**GENOA CHARTER TOWNSHIP
PLANNING COMMISSION
PUBLIC HEARING
September 9, 2013
6:30 P.M.
AGENDA**

OPEN PUBLIC HEARING #1... Review of site plan, special use, and environmental impact assessment for proposed 16,120 square-foot gymnasium and classroom addition for Brighton Nazarene Church, located at 7669 Brighton Road in Section 25, petitioned by Brighton Nazarene Church.

Re: Brighton Nazarene Church Facility Expansion
Site Plan Review
Boss File No. 13-100

Attention:	Kelly Van Marter, AICP Assistant Township Manager and Planning Director
Subject:	Brighton Nazarene – Special Land Use and Site Plan Review #3
Location:	7669 Brighton Road – northwest corner of Brighton and Aljoann Roads
Zoning:	SR Suburban Residential District

SHEET NUMBER:
A200

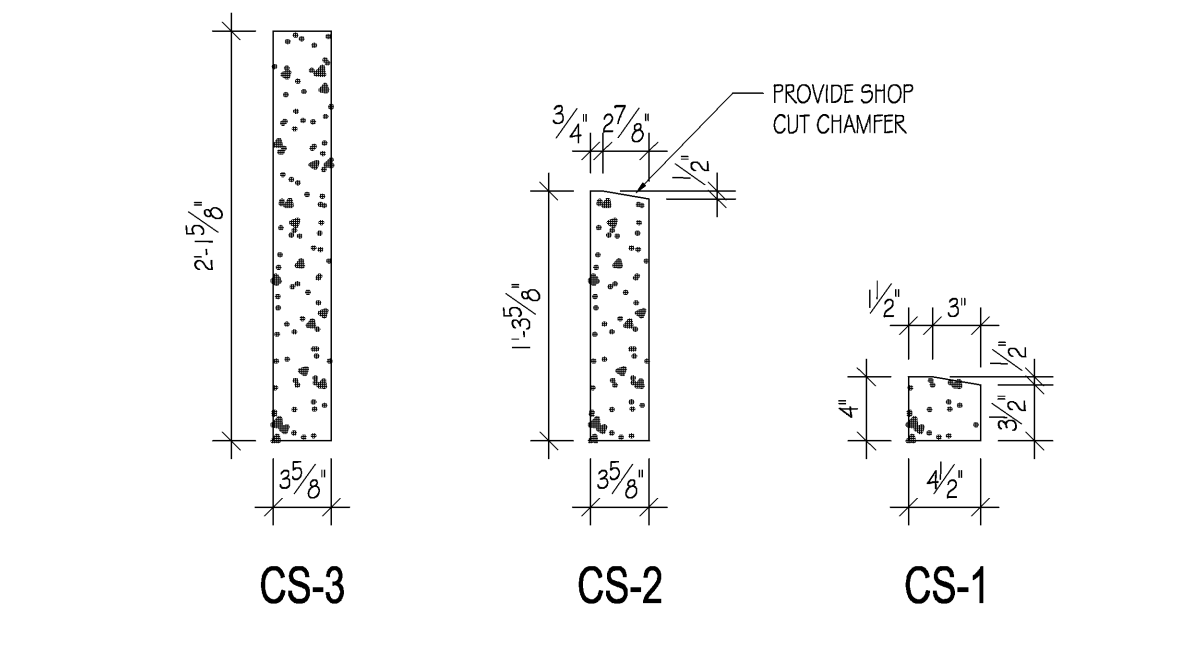
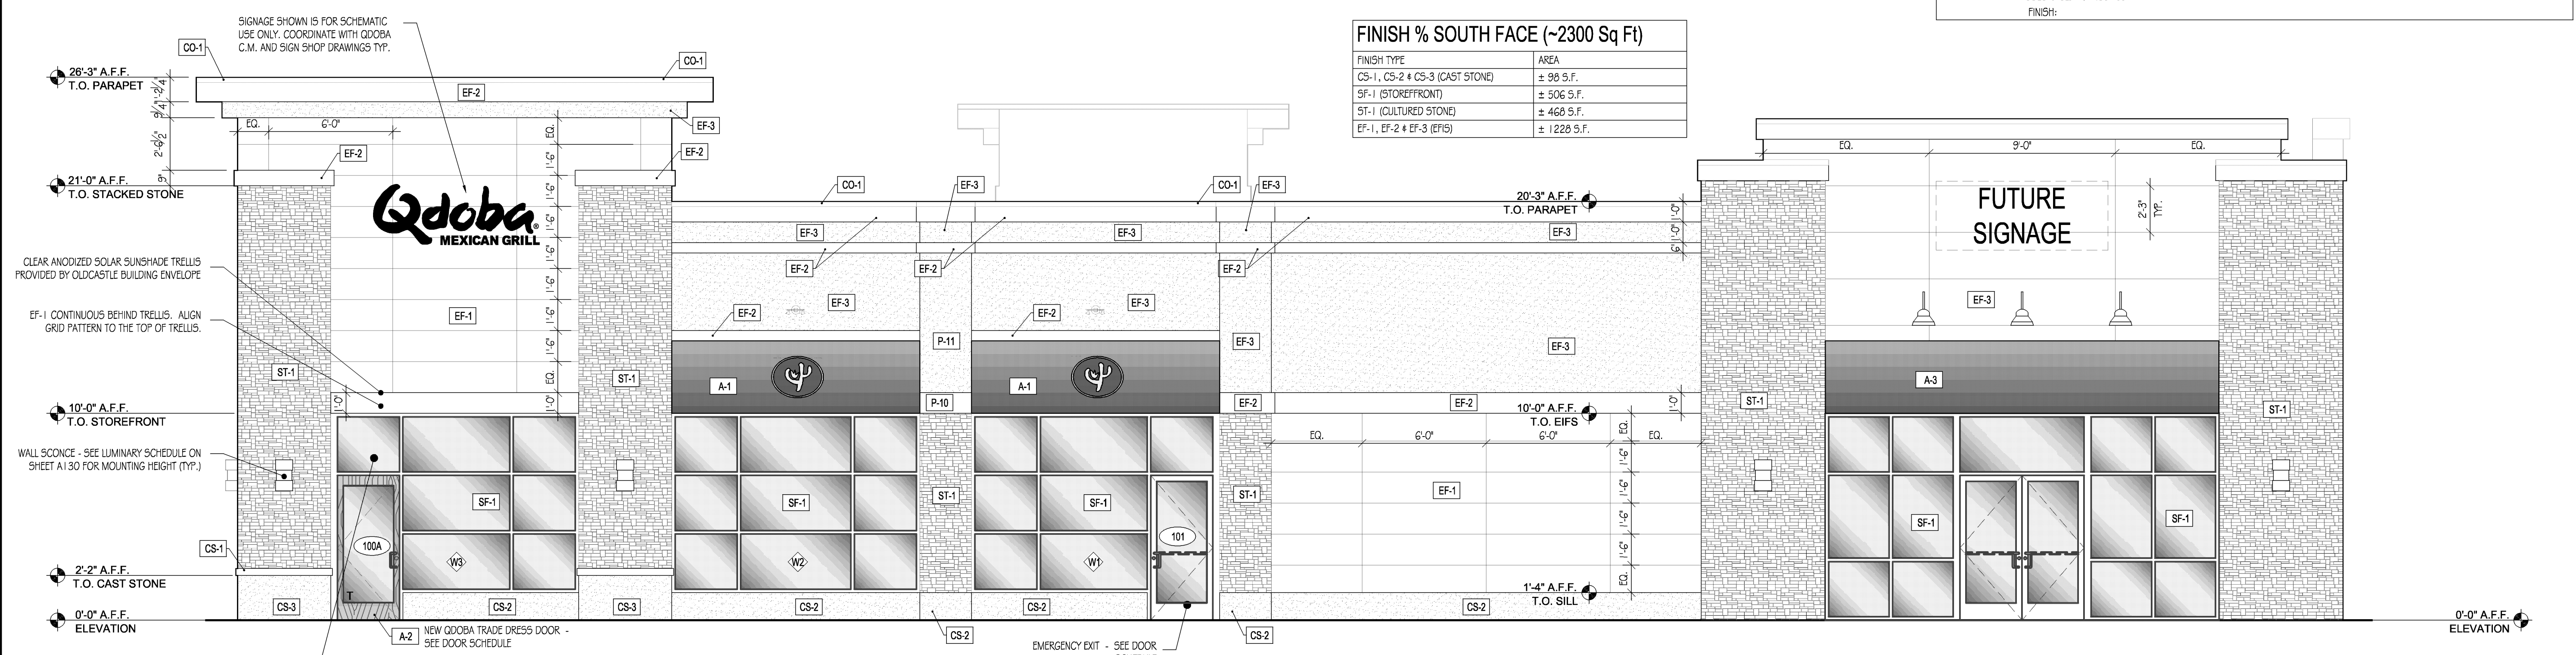
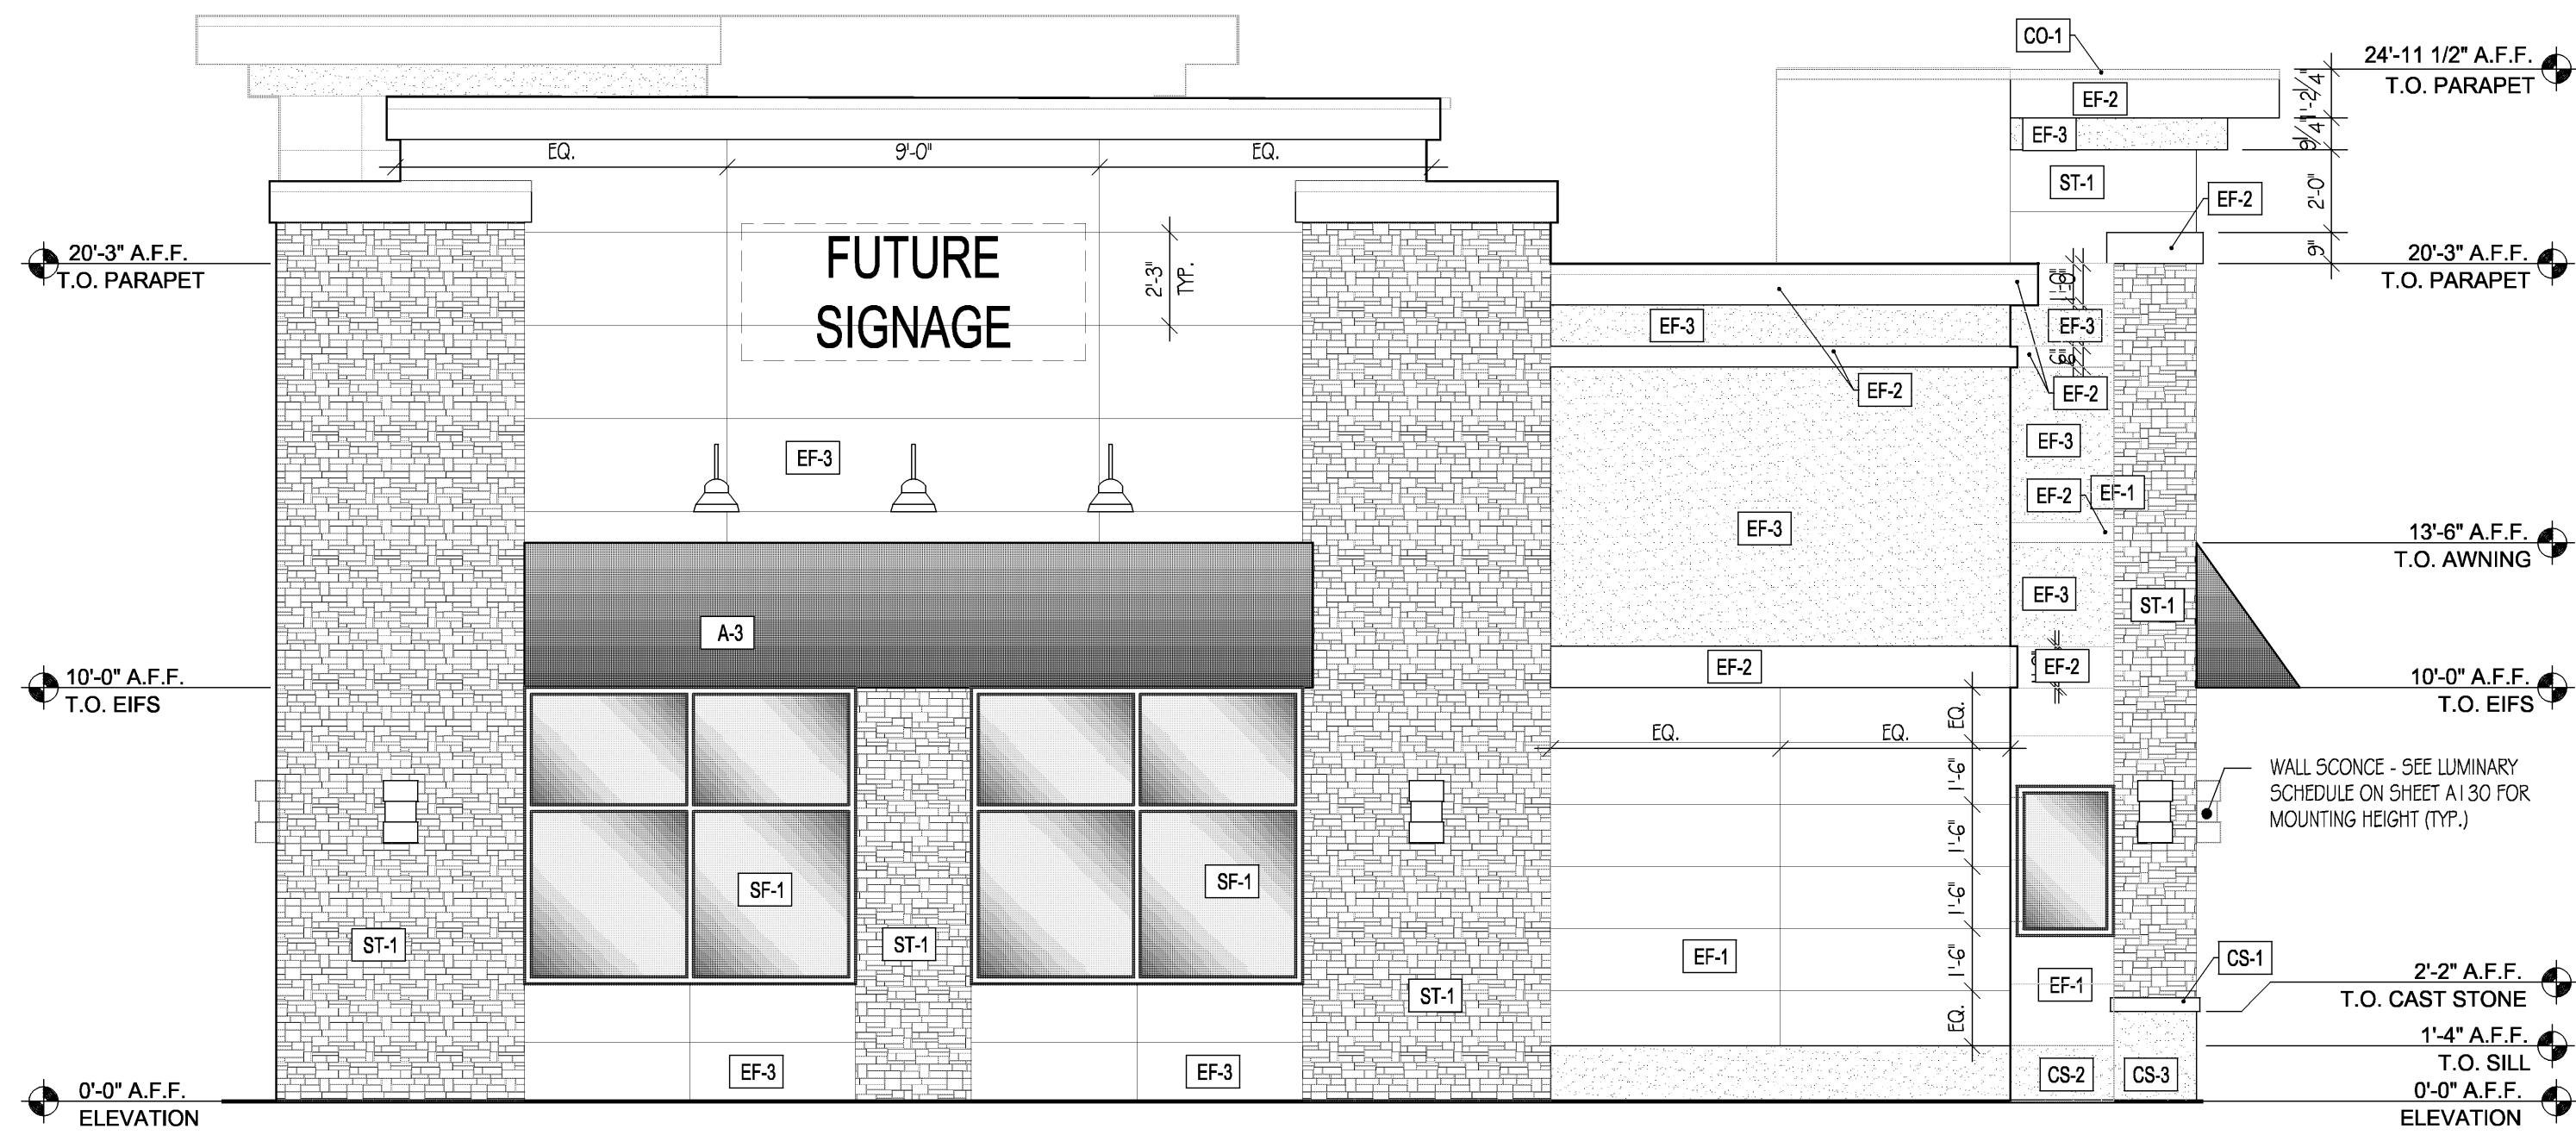
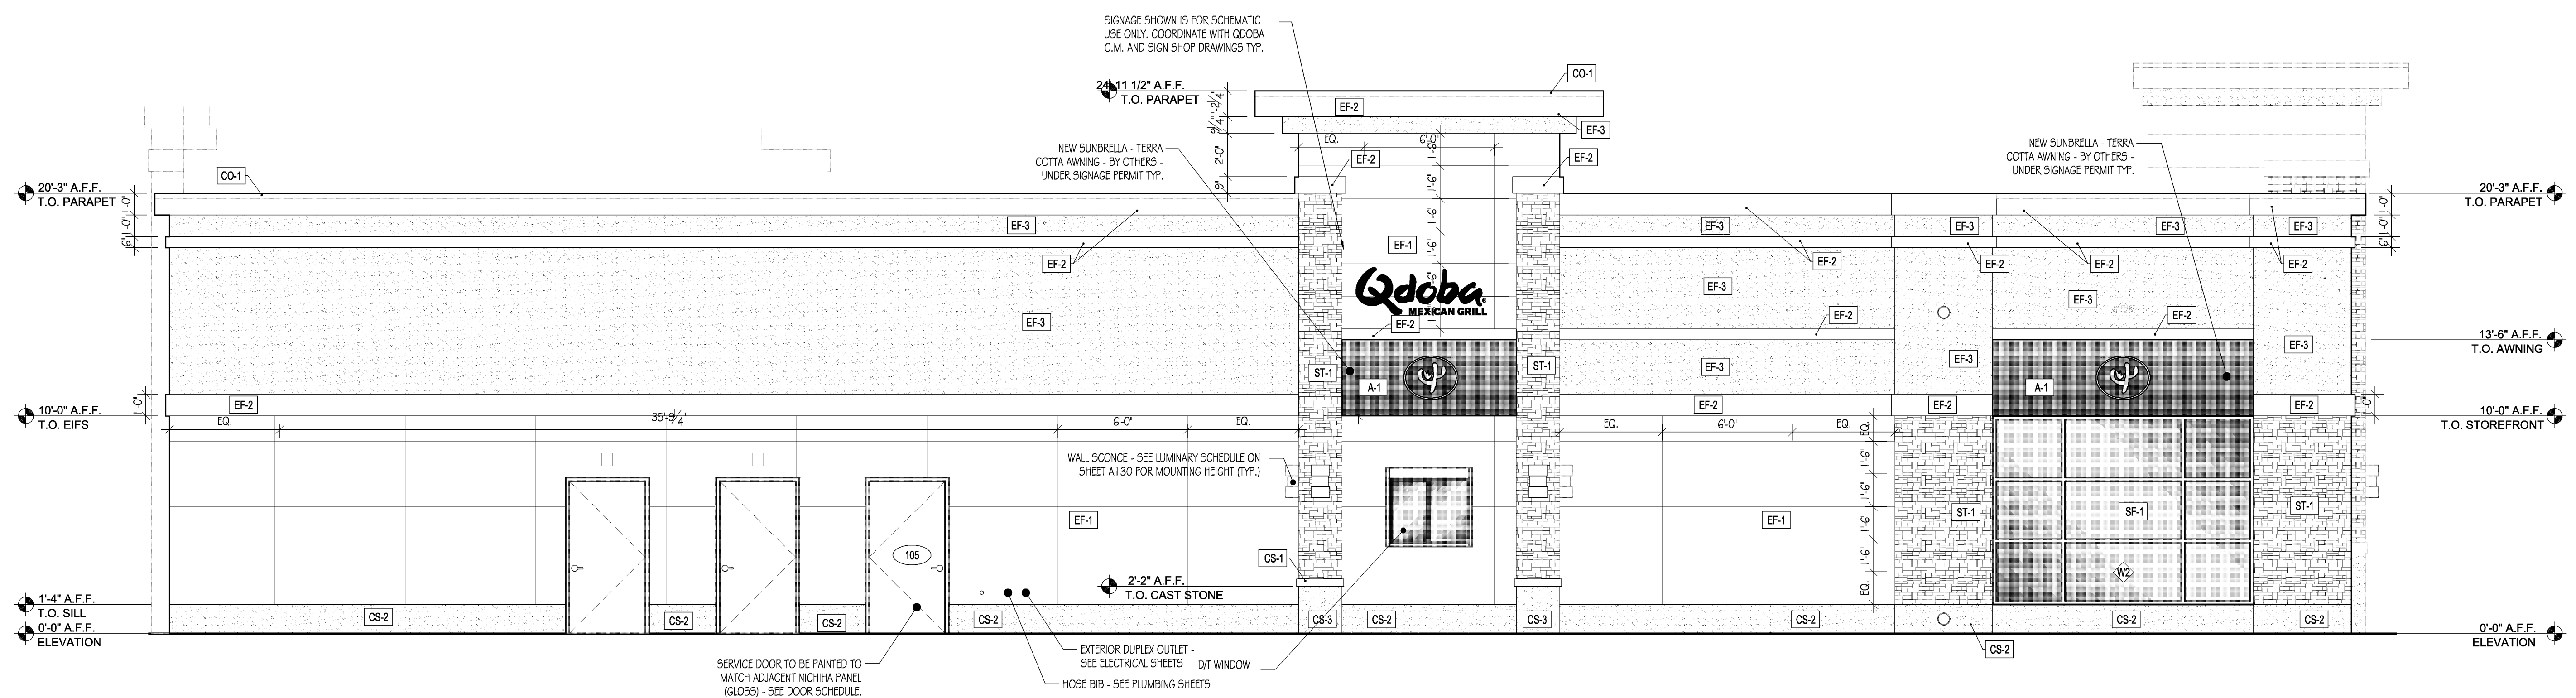
The primary building material is EIFS with large horizontal stone elements and large window areas. Based upon the information provided on Sheet A200, the amount of EIFS greatly exceeds that permitted by Section 12.01. Additionally, the PUD Agreement requires that each site plan submitted shall include a description (or illustration) of how the design is consistent with the architecture of other sites in the PUD. We request the applicant provide this information.
